UNITED STATES PATENT AND TRADEMARK OFFICE

APPLICATION NO.	FILING DATE	FIRST NAMED INVENTOR	ATTORNEY DOCKET NO.	CONFIRMATION NO.
10/025,821	12/26/2001	Satoshi Shinada	Q67781	4266

Office Action Summary

DETAILED ACTION

FIG. 1

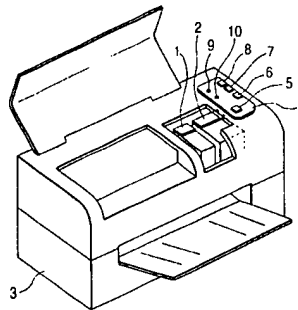
- {claim 1} An ink cartridge for an ink-jet recording apparatus (figure 1, references 1,2);

FIG. 4B

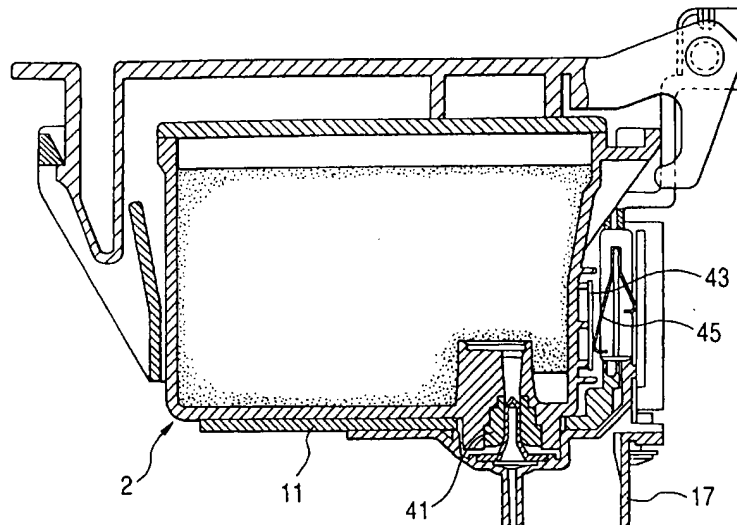
container body having an ink supply port (figure 4B, reference 41; container body drawn in);

- {claim 2} positioning system includes at least one recess that has an opening at a leading end thereof in an ink cartridge insertion direction, and that is engageable with the positioning member formed as a protrusion (figure 4B; positioning recessed portion, guiding protruding portion drawn in; it is seen that when the lever is lifted in a counter-clockwise direction around the gear, positioning recessed portion moves away from the guiding protruding portion; thus in the

alternate direction, the recess is engageable with the positioning member; thus the claim is inherent to the invention)

- {claim 4} recess has an upper end wall to be contacted with an upper end of the protrusion (figure 4B; upper end wall drawn in)
- {claim 5} the wall extends in parallel to a direction in which the electrodes are arranged (figure 3B; wall drawn in between contact electrodes and positioning recessed portion; it is seen that the wall extends in parallel to a direction in which the electrodes are arranged)

- {claim 10} circuit board having the electrodes is accommodated in a recessed portion formed in the container body (figure 4B, references 43, 45)
- {claim 11} the positioning recessed portion is formed at a position below a circuit board having the electrodes (figure 4B, references 43, positioning recessed portion)

- {claim 20} the positioning system contacts the positioning member to align the electrodes with respective contacts in at least two directions of a carriage moving direction, a paper feeding direction, and a vertical direction in a state in which the electrodes contact the contacts (figure 4B, reference 43, 45)

- {claim 21} the positioning system contacts the positioning member to align the electrodes with respective contacts in at least two directions of a carriage moving direction, a paper feeding direction, and a vertical direction in a state in which the electrodes contact the contacts (figure 4B, reference 43, 45)

FIG. 3B

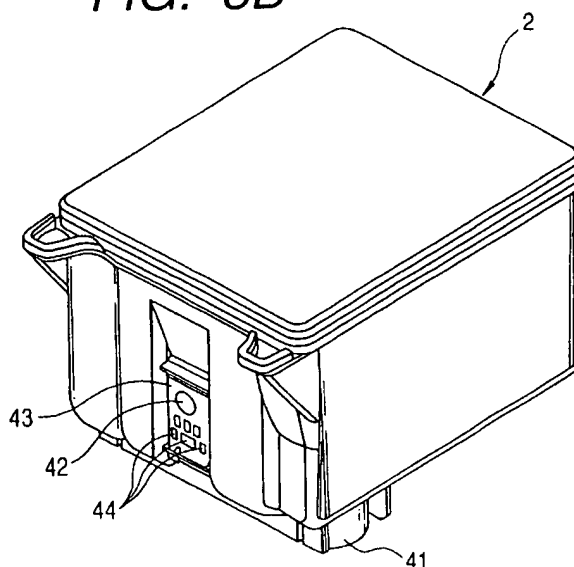
a storage element disposed on the container body (figure 3B, reference 42);

electrodes to be in contact with respective contacts provided in the recording apparatus accommodating the container body therein (figure 3B, reference 44; figure 4B, reference 43 and 45; contacts represent contact electrodes); positioning system which is formed in the vicinity of the electrodes and is adapted to engage a positioning member of the recording apparatus, wherein the positioning system contacts the positioning member (figure 4B; hook portion, lever, protruded portions, gear, and projections drawn in; it is seen that when the lever is lifted in a counter-clockwise direction around the gear, the projection engages the protruded portions, which behave as positioning members for the recording apparatus; thus the claim is naturally suggested in the invention)

- {claim 3} at least one recess includes a pair of recesses located opposite from each other with respect to the electrodes (figure 3B; additional recess drawn in; it is seen that positioning recessed portion and additional recess are located opposite from each other with respect to the electrodes)

- {claim 6} a contact area between the wall and the positioning member is wider than a width of an area in which the electrodes are arranged (figure 3B; the width of the area between the wall and the positioning member is [W1] and the width of the area in which the electrodes are arranged [W2] are drawn in; it is seen that $W1 > W2$)

- {claim 8} the storage element and the electrodes are mounted on a same flexible cable (figure 3B, references 42, 44; column 3, lines 19-21; figure 3B shows the storage system being on the same cable strip as the electrodes and column 3 teaches that the storage element is located on a flexible cable; thus it is inherent to the invention that the electrodes are also located on the flexible cable)

- {claim 12} a pair of the positioning recesses are provided to be located to be opposite from each other with respect to the electrodes (figure 3B)
- {claim 13} the container body has a recessed portion for accommodating a circuit board having the electrodes, and has a wall which defines the recessed portion and is brought into contact with a top surface of the protruding portion (figure 4B, reference 43, 45, upper end wall, positioning recessed portion, guiding protruding portion)

- {claim 14} the wall extends in parallel to a direction in which the electrodes are arranged (figure 3B)
- {claim 15} a contact area between the wall and the protruding portion is wider than a width of an area where the electrodes are arranged (figure 3B)

- {claim 16} the storage element is mounted on a circuit board (figure 3B, references 42-43)
- {claim 17} a flexible cable is connected to a circuit board having the electrodes, and the storage element is connected to the electrodes through the flexible cable (figure 3B; column 3, lines 19-21)

The applicant submits that “the ‘protruded portion’ of figure 3B is not a positioning system which is formed in the vicinity of the electrodes, as recited in claim 1. As shown in figure 3B, the protruded portions are located at the top right and left corners of the front face of the jet ink cartridge, away from and not in the vicinity of the electrodes 44. To the contrary, in Seino, the electrodes 44 are formed in the lower half of the front face of the jet ink cartridge, away from the protruded portions. Furthermore, nowhere in Seino is there any disclosure of a positioning system which contacts the positioning member, as recited in claim 1. Since the Examiner has not shown how the positioning system which is formed in the vicinity of the electrodes and which contacts the positioning member is inherently disclosed to one skilled in the art, Applicants submit that claim 1 is patentable.” The examiner submits that though the figures of Seino et al don’t explicitly show, the protruded portions (as drawn in) engaging the projections (as drawn in) to form a positioning system, the positioning system is there nonetheless. It should be clear to one of ordinary skill in the art that the projection must meet the protruded portions in order for the ink supply needles to engage the ink supply port and for the circuit board to meet the contacts of the recording device. The rotating action is not explicitly shown, but is always the case for a set-up as shown in figure 4B. Hence, the examiner maintains that the claimed limitation is inherent to the invention of Seino et al.
